# SERVICE CAMPAIGN BULLETIN

NTB13-052b

## VOLUNTARY SERVICE CAMPAIGN 2013 ALTIMA SEDAN HEATED SEATS

**CAMPAIGN ID:** PC212

Figure 1; seat viewed from bottom rear

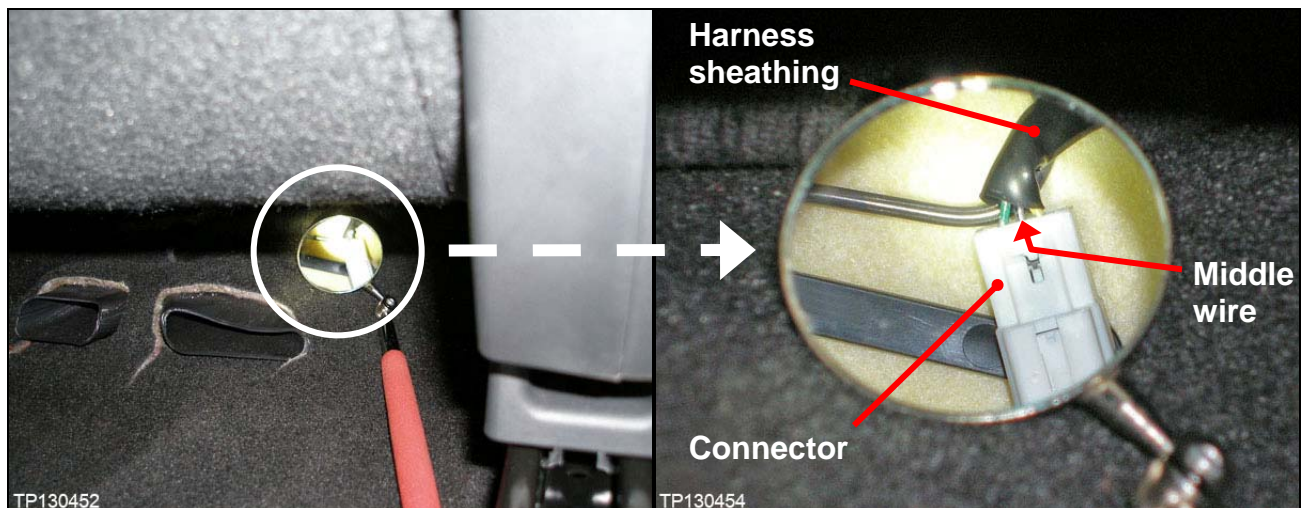
1. Move both front seats fully forward, and then adjust the seatbacks forward.
2. From the rear of the front seats using a mirror and flashlight, locate the white 3-wire harness connector under the seat frame assemblies of BOTH front seats (see Figure 1).
  - Look **ONLY** at the side of the white connector where the wire colors are green, yellow, and black.
  - **IGNORE** the wires on the other side of the white connector.
  - The harness sheathing may need to be pulled back for good viewing.
  - See next page for a detailed picture.

Figure 3; picture taken with seat lifted for easier viewing only.

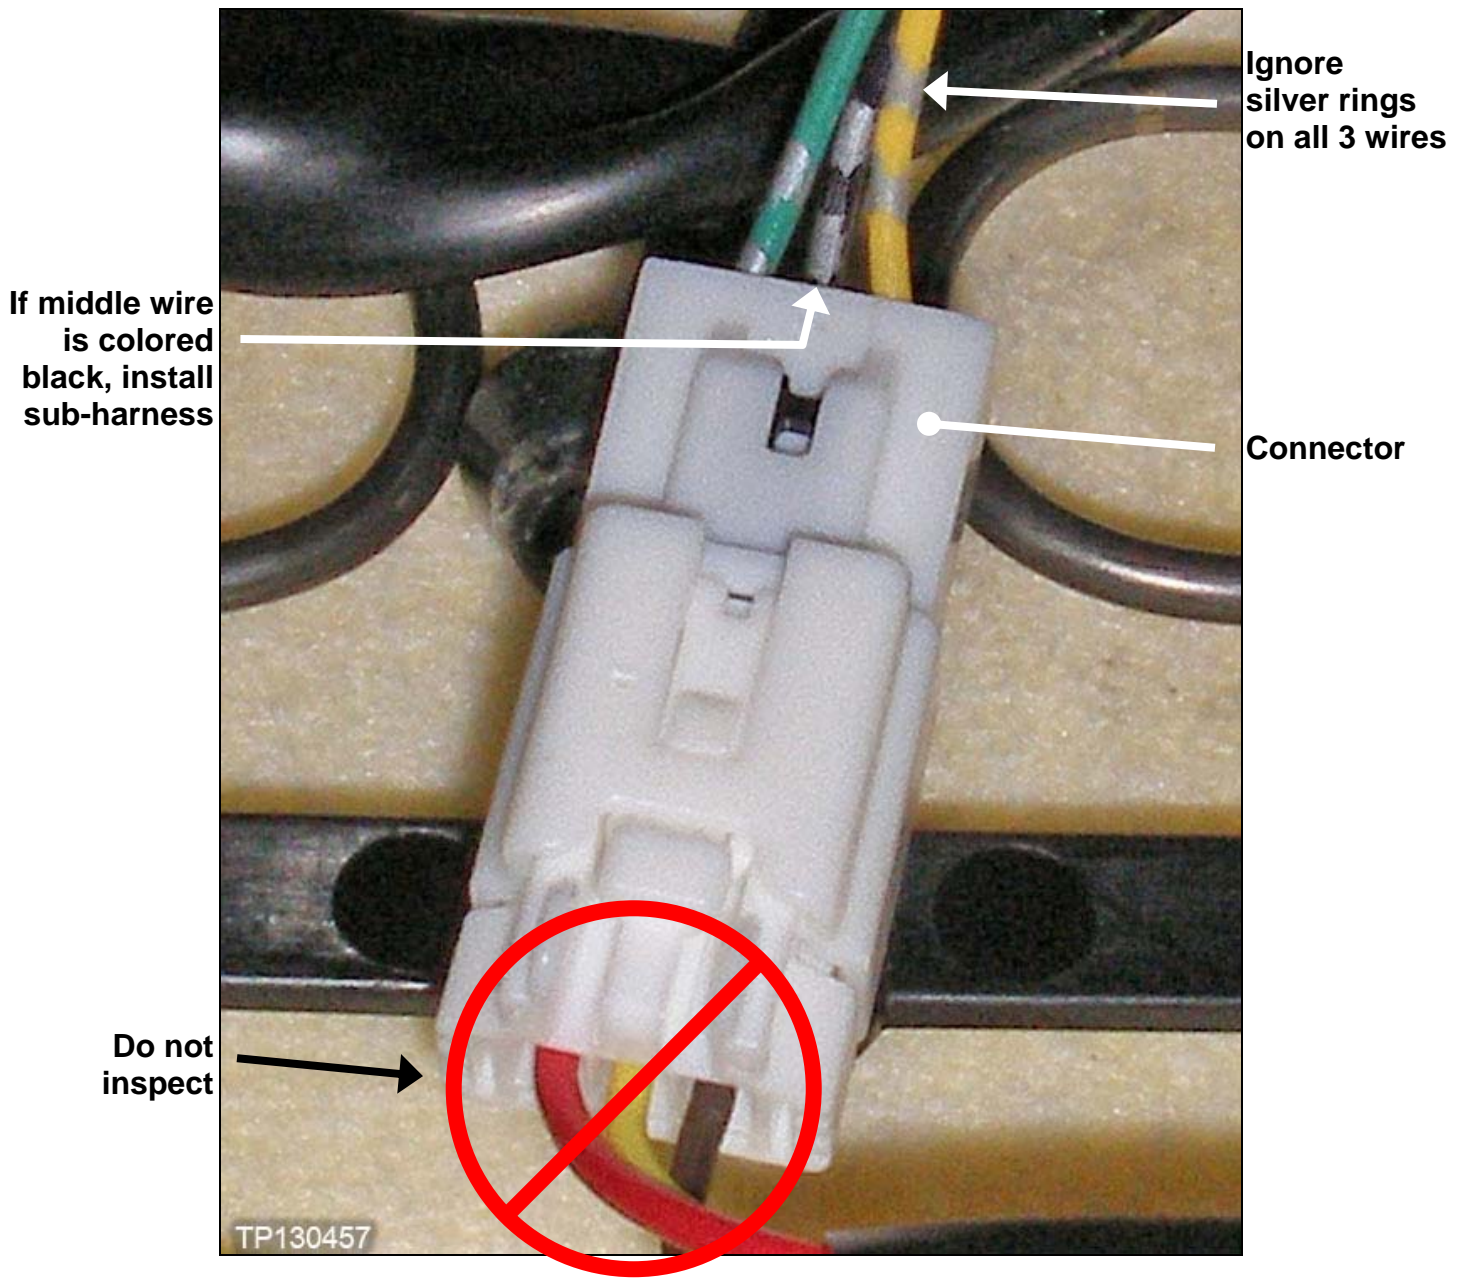
3. For seats where the middle wire is black (see Figure 3): Install a sub-harness listed in **PARTS INFORMATION**.
  - Go to **Install Sub-harness(es)** on the next page.
4. When the middle wire is NOT black on BOTH seats: No further work is needed. Go to **CLAIMS INFORMATION**.

Figure 5

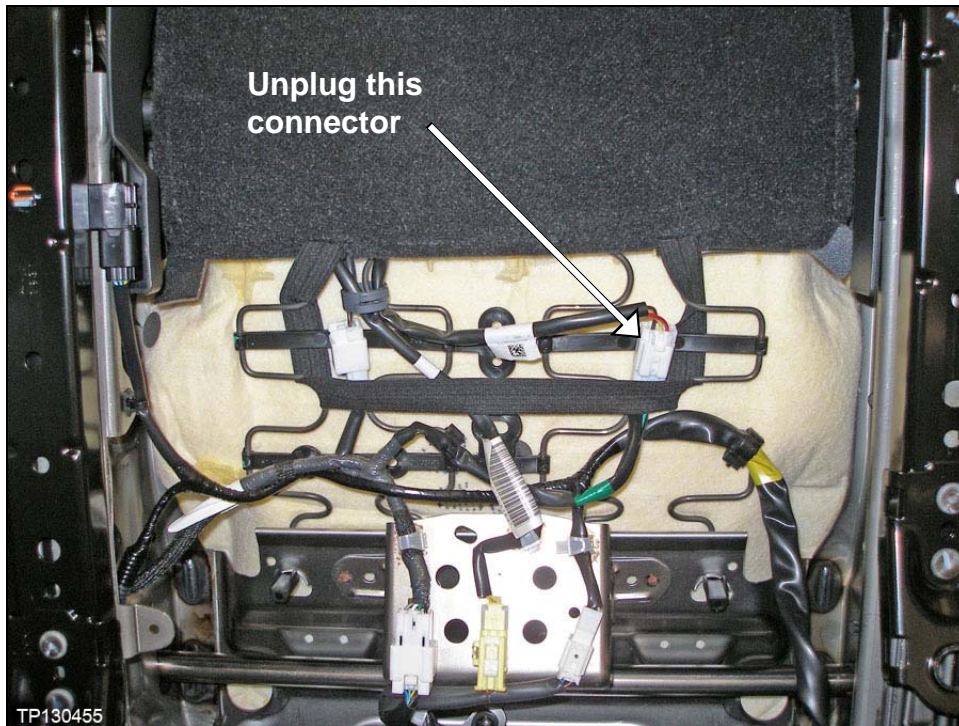
4. Unplug the seat harness(es) where noted in Figure 5.

Figure 6

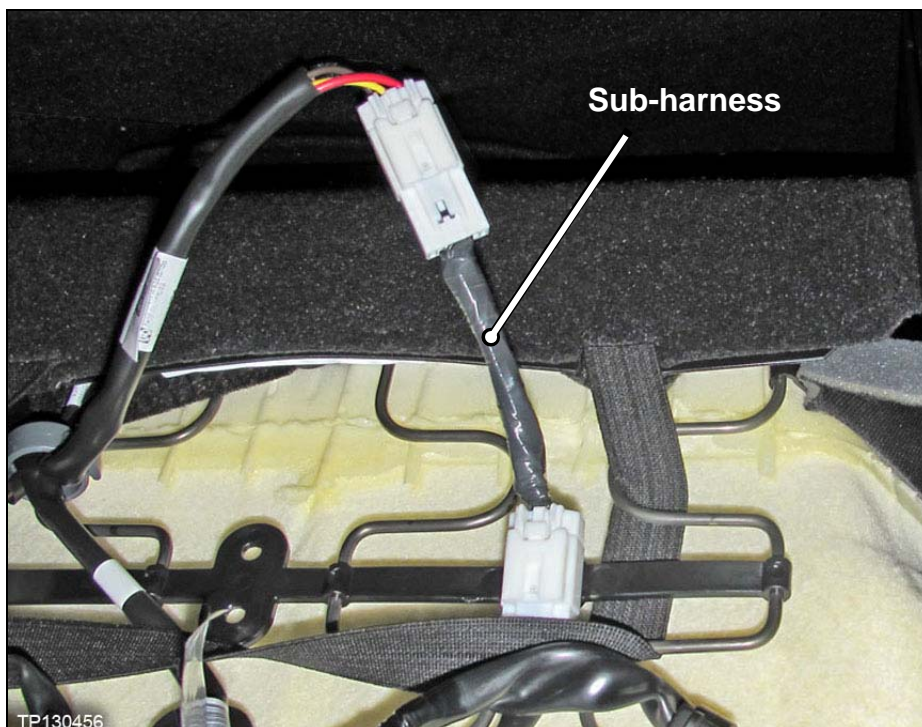
5. Plug in the sub-harness(es). See **PARTS INFORMATION**.

Figure 7

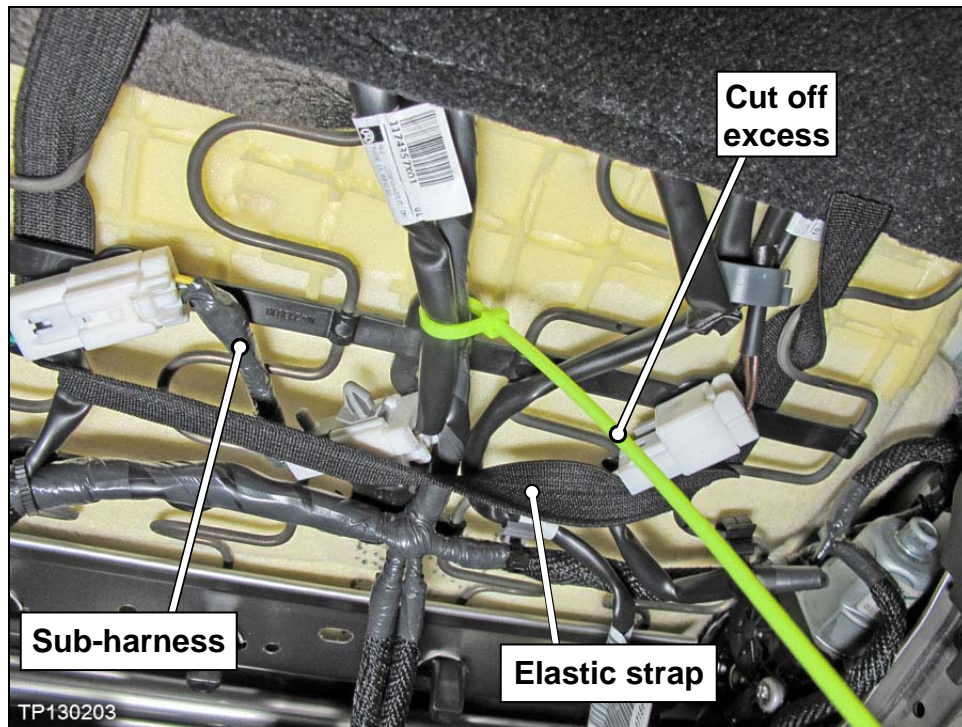
6. Re-secure the seat harness(es) with a tie strap where noted in Figure 7.
  - Cut off excess tie strap material.
